DEVELOPMENT PROJECT APPLICATION FORM

Project Name: Village of Pemberton Daycare

- A0.0 COVER PAGE
- A0.1 CONSTRUCTION ASSEMBLIES, ROOF PLAN
- A0.2 CODE REVIEW
- A0.3 SITE PLAN
- A0.4 SERVICES PLAN
- A1.0 OVERALL FLOOR PLAN
- A1.1 AREA PLAN
- A1.2 WINDOW & DOOR LEGENDS
- A2.0 OVERALL CRAWL SPACE PLAN
- A3.0 EXTERIOR ELEVATIONS
- A4.0 BUILDING CROSS SECTIONS
- A4.1 BUILDING WALL SECTIONS
- A4.2 STAIR & RAMP DETAILS
- A8.0 OVERALL RCP

PROJECT TITLE: VILLAGE OF PEMBERTON 7396B COTTONWOOD STREET DAYCARE		P22973	As indicated
DRAWING TITLE: CONSTRUCTION ASSEMBLIES, ROOF PLAN		DRAWN BY: RMM	DATE: 26 MAY 2023
		A0.1

DRAWING TITLE:
BUILDING CROSS SECTIONS

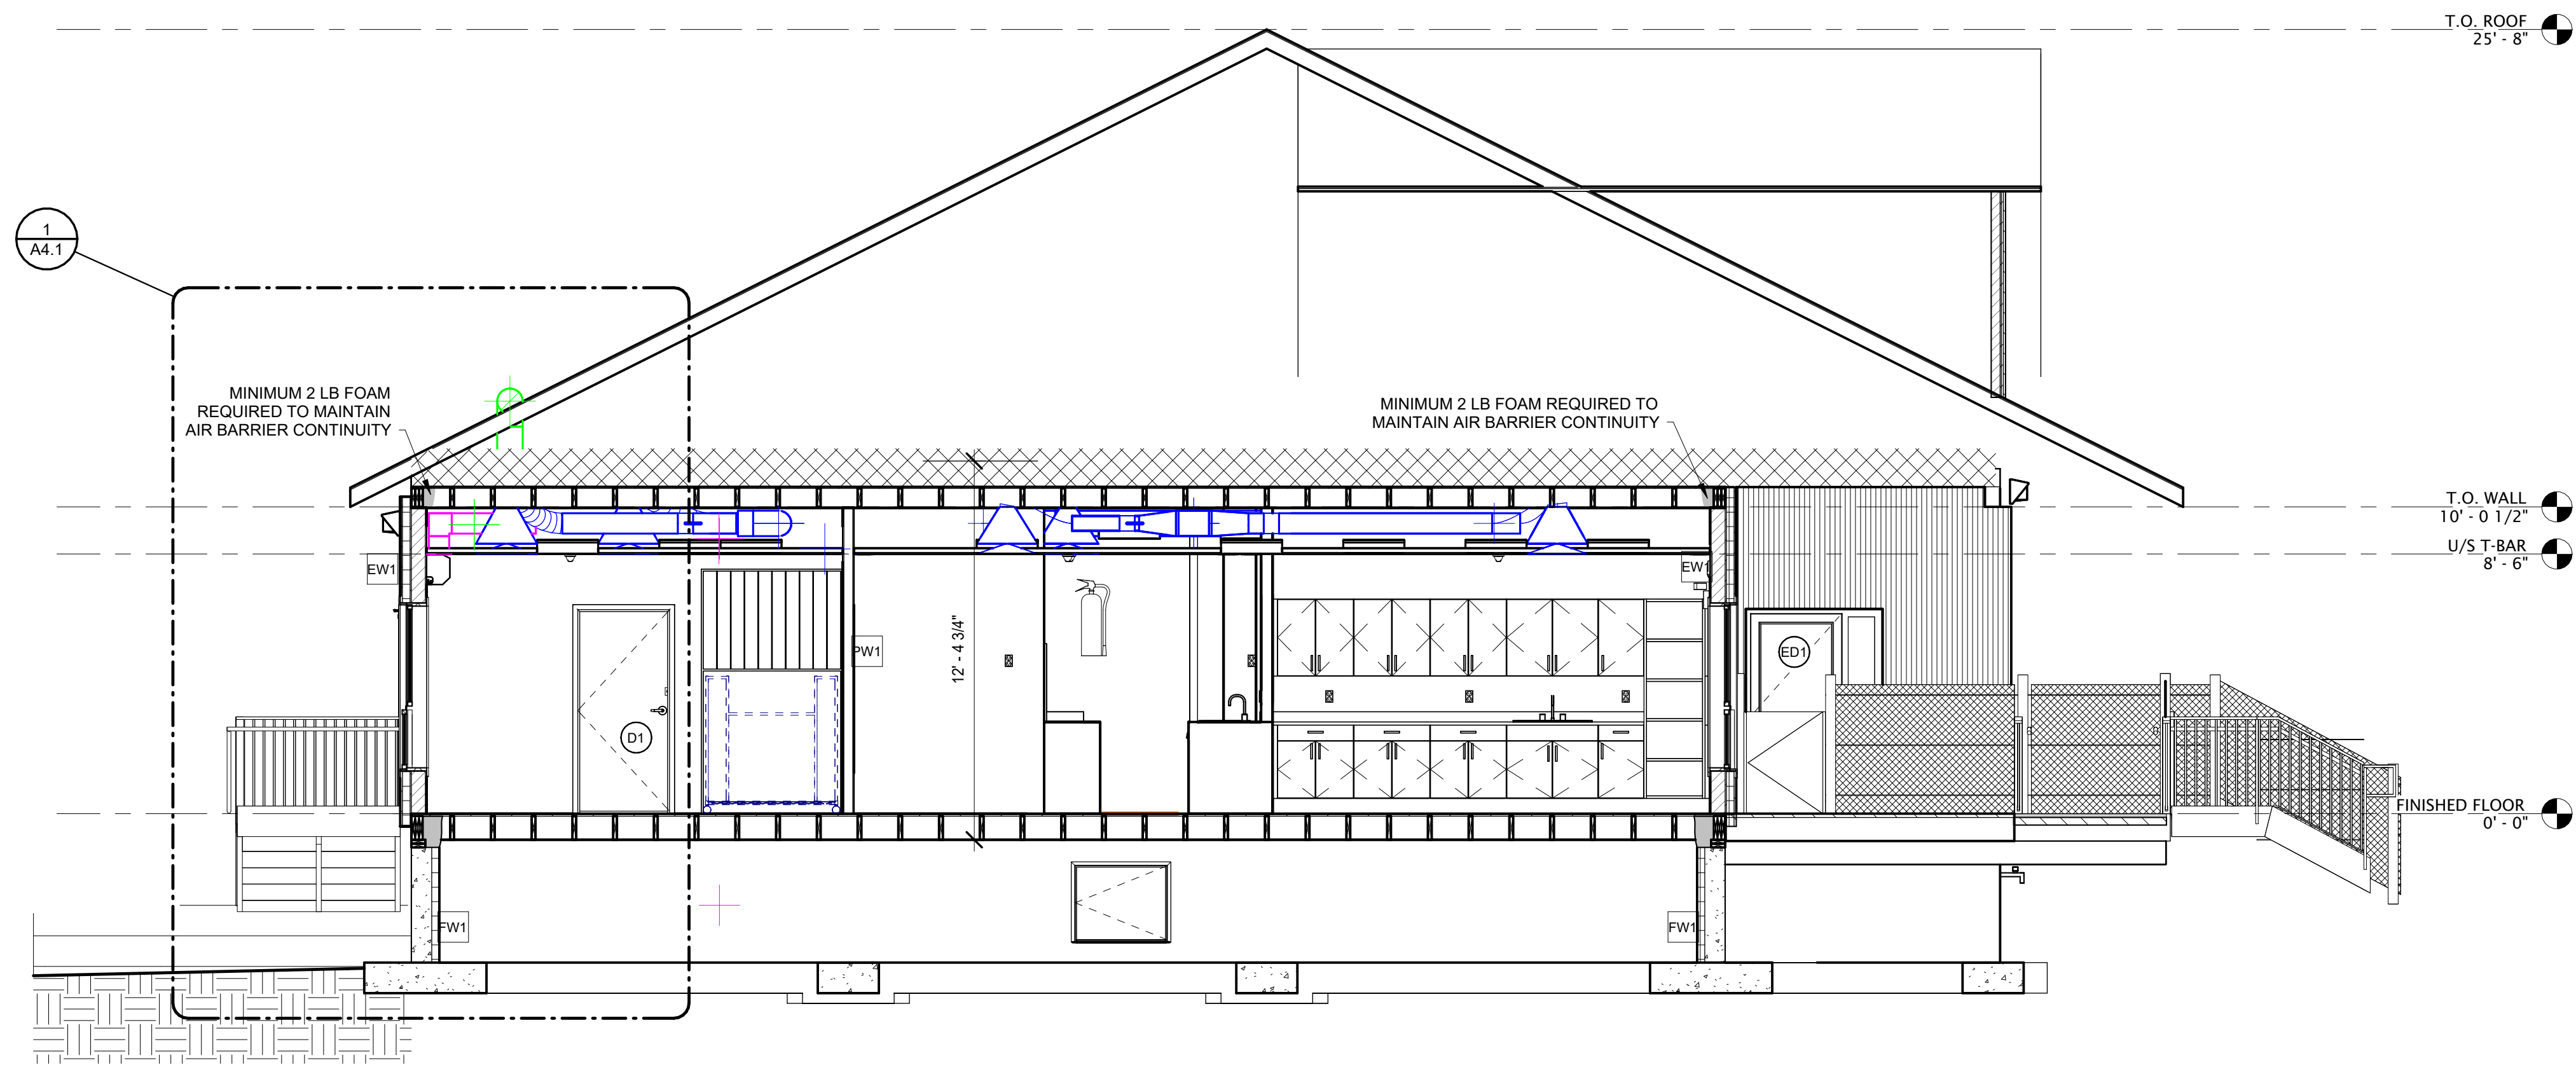
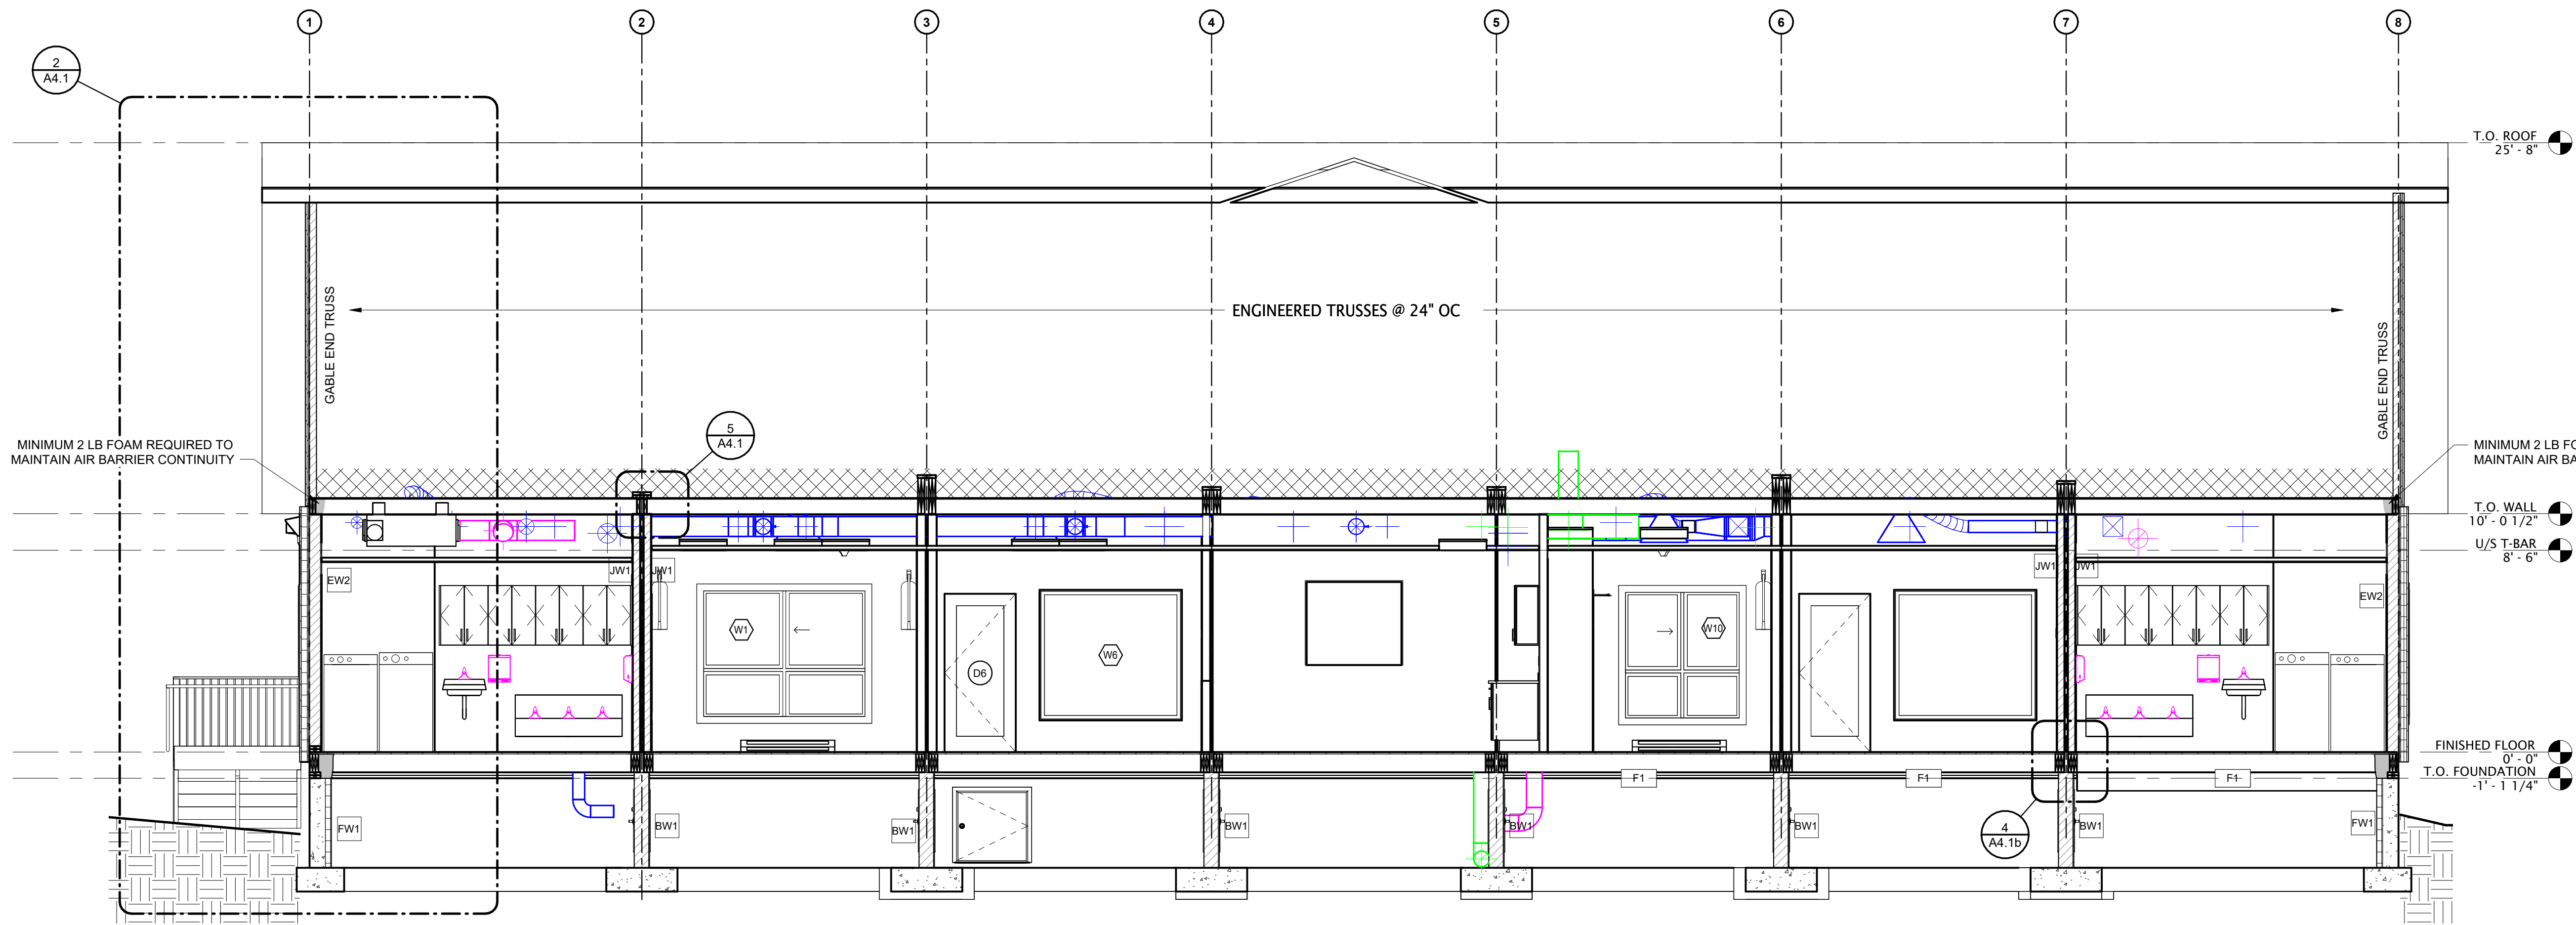
- PLAN CHECK PAGE NOTES:**
1. FIRE EXTINGUISHERS SHALL BE INSTALLED IN ACCORDANCE WITH NFPA 10.
 2. BUILDING ACCESSIBILITY INCLUDING STAIRS, RAMP, LANDINGS, HANDRAILS AND GUARDS SHALL COMPLY WITH SECTION 3.8., DIVISION B, BCBC 2018 & THE BUILDING ACCESSIBILITY HANDBOOK 2020 (ILLUSTRATED COMMENTARY ON ACCESSIBILITY REQUIREMENTS).
 3. STAIRS, RAMP, GUARDS & HANDRAILS SHALL COMPLY WITH 3.4.6., DIVISION B, BC BUILDING CODE.
 4. FIRE BLOCKING IN CONCEALED SPACES SHALL BE IN CONFORMANCE WITH 3.1.11., PART 3, DIVISION B, BCBC 2018.

DRAWING TITLE:
OVERALL RCP

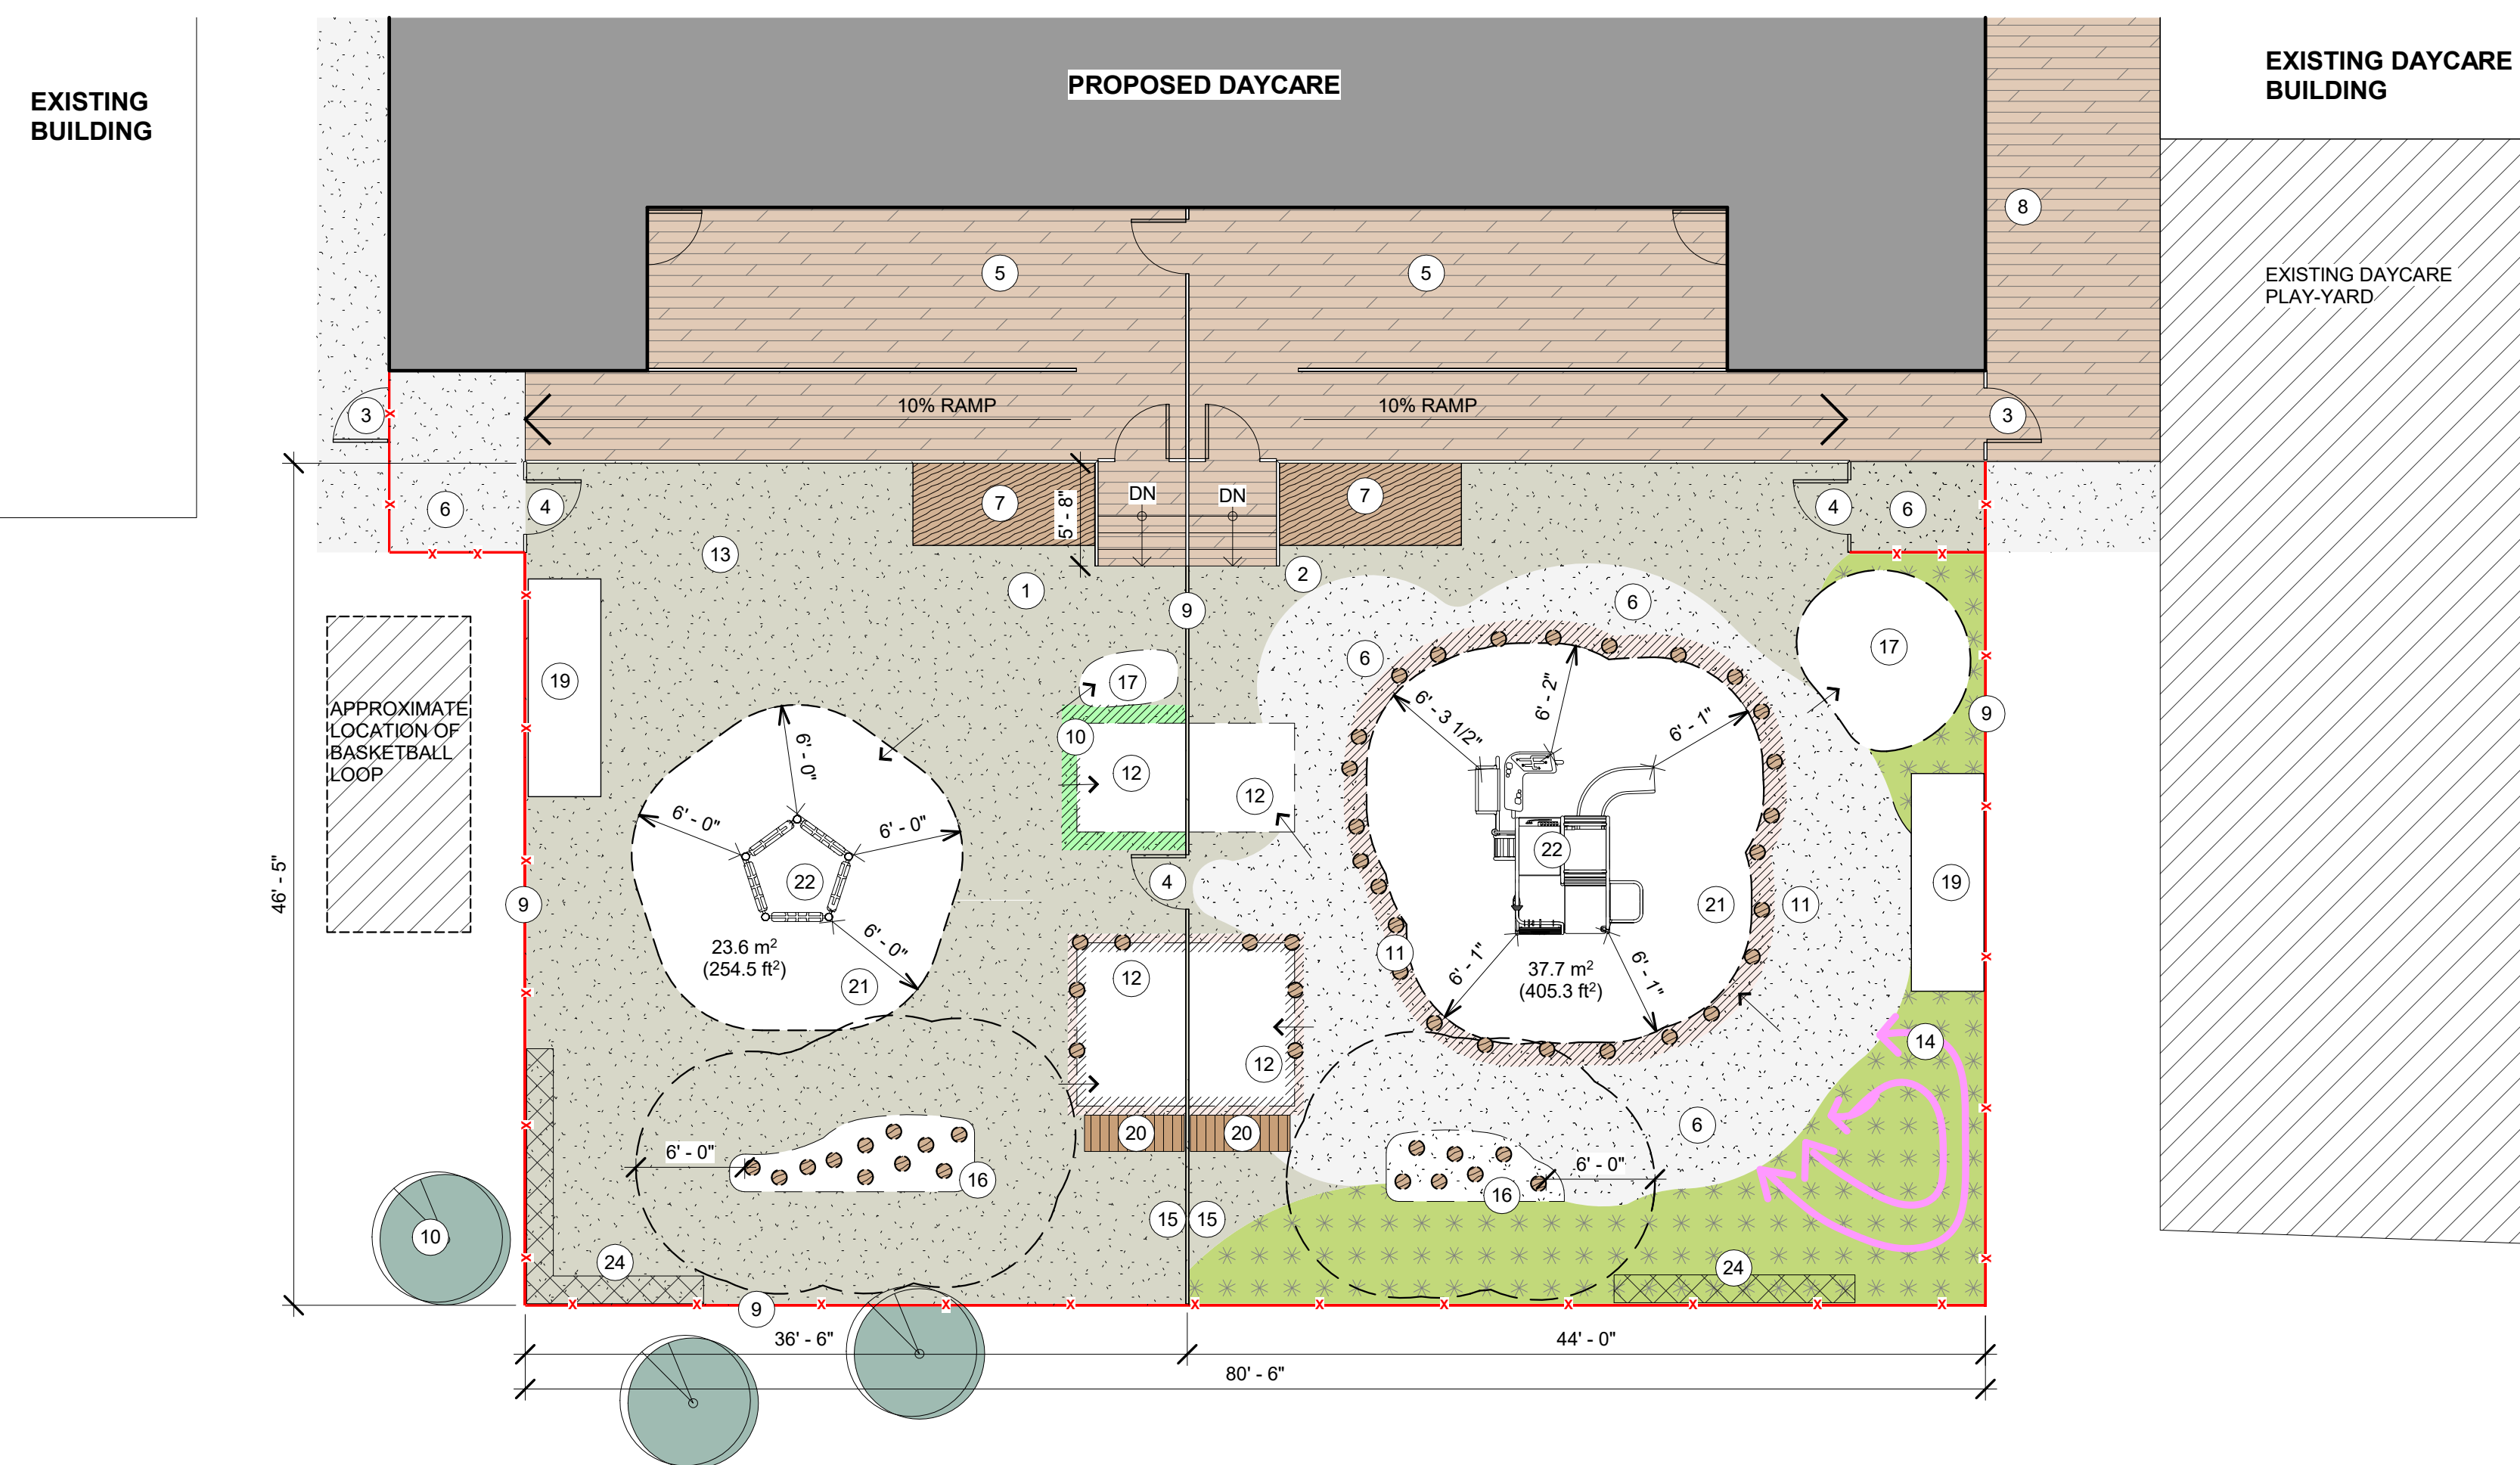
PLAN CHECK PAGE NOTES:
 1. EMERGENCY LIGHTING NO LESS THAN 10 Lx AT THE FLOOR (TYPICAL), 3.2.7.3., DIVISION B, PART 3, CBC 2018.
